PDS-21 MOTOR UPDATE – 2021

March 23, 2021 – This is notice to inform distributors and consumers that the 2 Stage Vac Motor utilized in the VIKING PDS-21 (Pressurized Drying System) Wall Cavity Dryer has been updated.

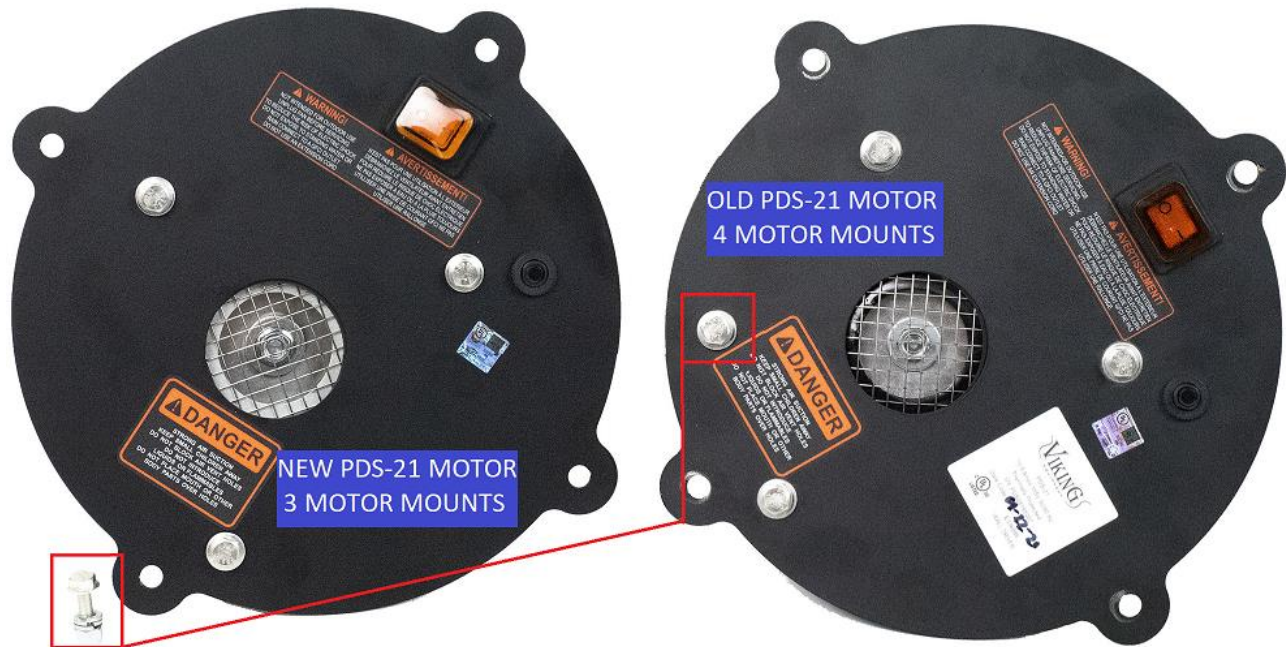
The above image displays the new motor (left) and previous motor (right) attached to the faceplate. Please note that the new motor on the left now has 3 motor mounts, reduced from 4 motor mounts seen on the right. New motors can be attached to existing faceplates with 4 mounting holes by utilizing 3 of 4 mounting points. The 4th motor mount on the old faceplate (red square on the right) can be blocked with nuts, bolts, & washers (red square on the left).

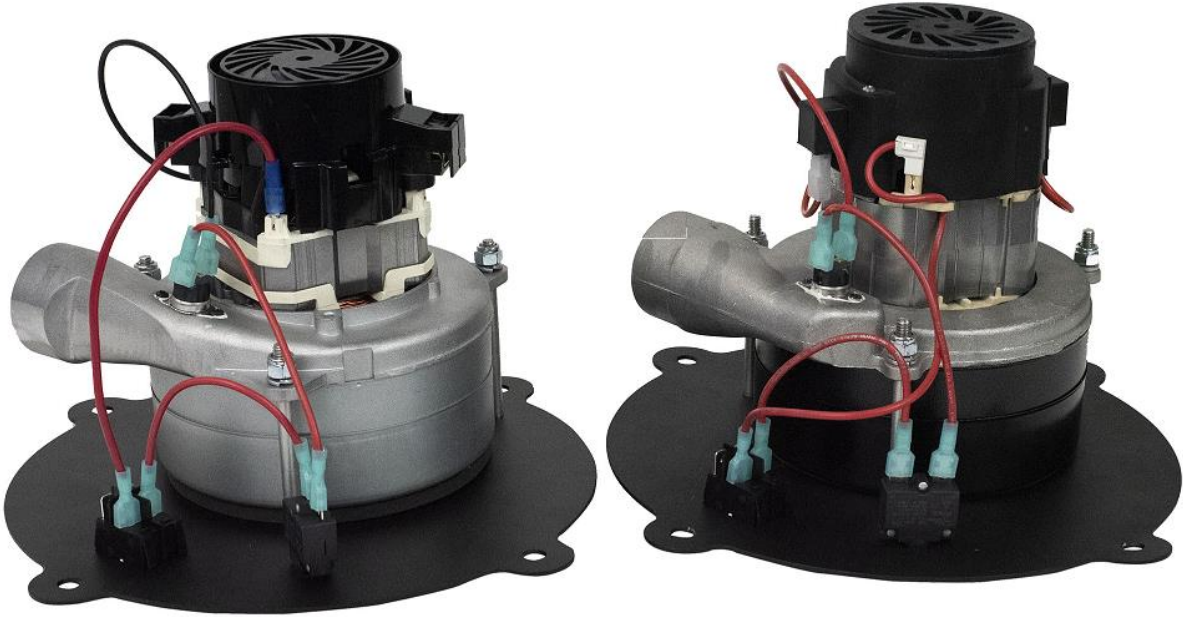
Please note that the fan covers on each motor are different. This will help in distinguishing which replacement brushes you will need to order. New motor (top left) previous motor (top right) correlate with the brushes seen below.

PART # 011-007

PART # ***DISCONTINUED***
